Reviewing And Updating The Comments of The Irrigation system For Strawberry Crop In Open Field (STRAWBEX)

This reviewing report is based on the verification report (TR/CLAES/211/2001.4)

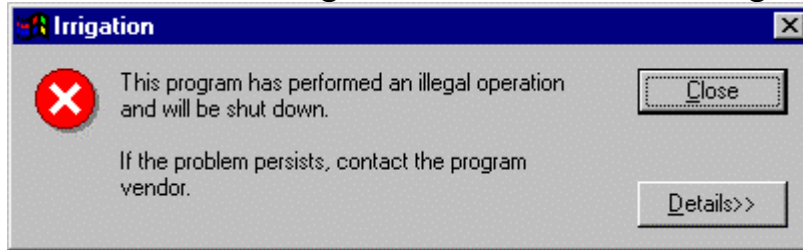
- When session running is finished this error message appear.

Comment: this error did not appear in the version I have in my computer.
